RECEIVED QUESTIONS :

Q: For the Space Agency project in St-Hubert, carpet tile is indicated without a distributor in the specifications. We would need to have this information to confirm the price.

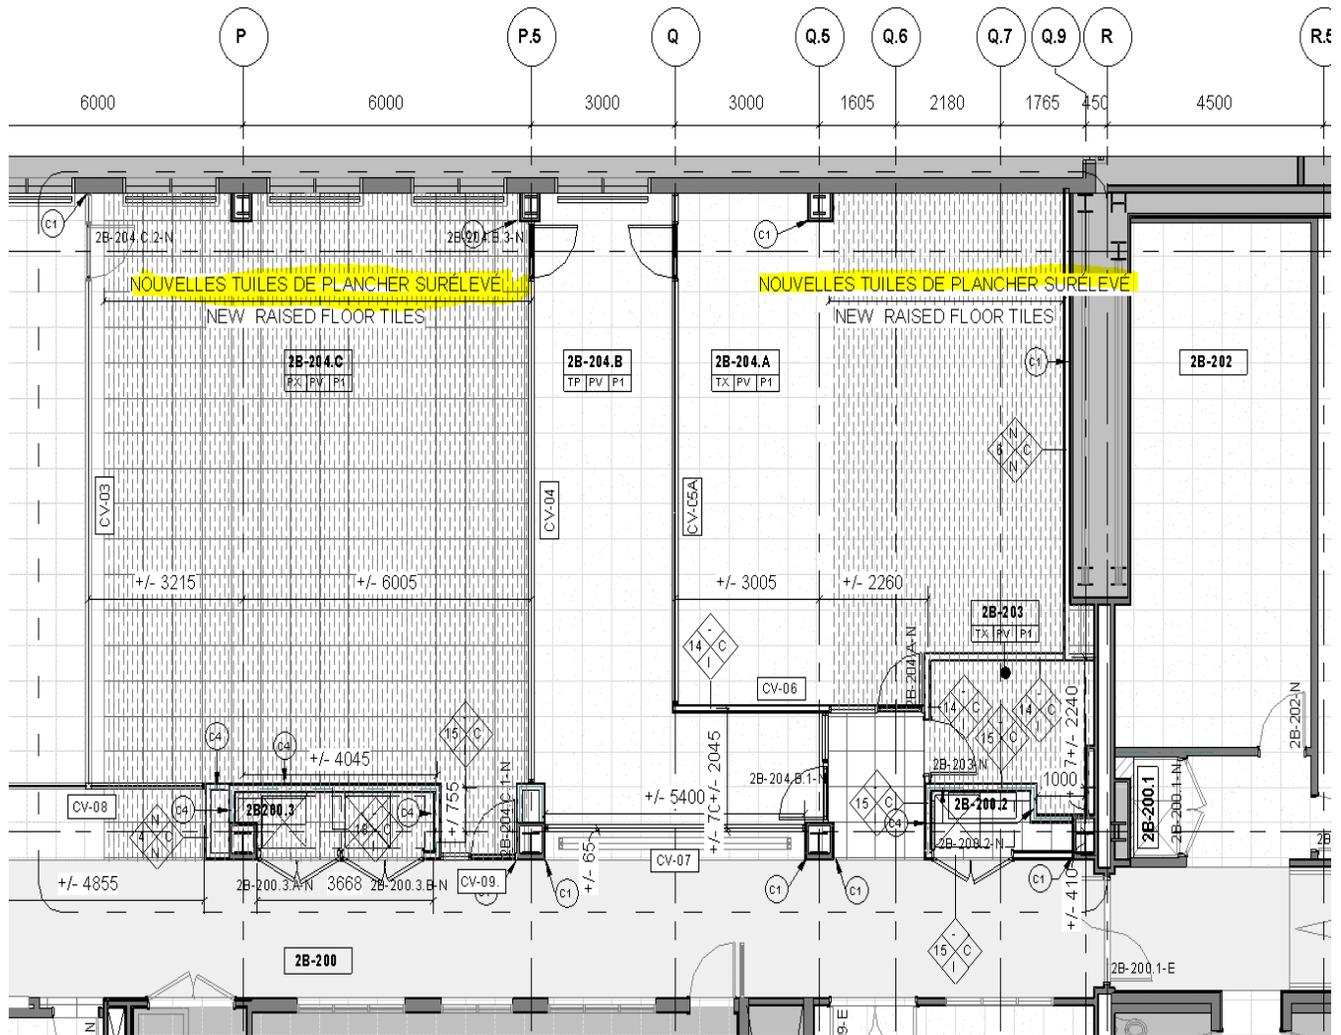
- The temporary partition work are included on the architectural drawings. Is the identification of temporary partitions on mechanical drawings for information only?

- Compartmentalization of the under floor of work zones is directly related to the partition work and certain wall demolitions (ex: plan A053 notes D4 and D7). We consider that the General contractor is the best party to estimate the needs and coordinate the workers as a whole to efficiently manage dust propagation. In addition, we consider this work outside of our scope as ventilation sub-trades to determine details and required locations. This work should be in the scope of the general contractor. Please clarify.

- According to the architectural drawings, ceilings are to be demolished in totality at every phase. The raised floor is modified in many locations. The specialized sub-trades of every mechanical division cannot be divide work amongst themselves or be responsible for cleaning under the raised floor or above the ceiling as required in section 20 00 10 article 1.36. Please confirm that the task of cleaning and testing the dust levels will be in the General contractor's scope.

- Existing ventilation ductwork to be cleaned is not identified. Is this included in this project?

A: BPA - All temporary partitions shown on MEP drawings are shown for reference only.

BPA - The notes on the architectural drawings are referring to the dismantling of the existing underfloor partitions. Article 1.3.3.1.3.17 of section 23 05 00 deals with temporary partitions that are needed during construction of each phase. Specifications are requesting that the HVAC subcontractor takes care of making the perimeter of each construction zone air tight for the time of the construction of each phase so that all other areas that are not under construction remain operational and that air be supplied from the underfloor plenum everywhere but within the construction zone.

BPA - Article 1.36 will be revised in an upcoming addendum.

BPA - All existing conduits that are located within a construction zone shall be cleaned. Article 1.36 will be revised in an upcoming addendum.
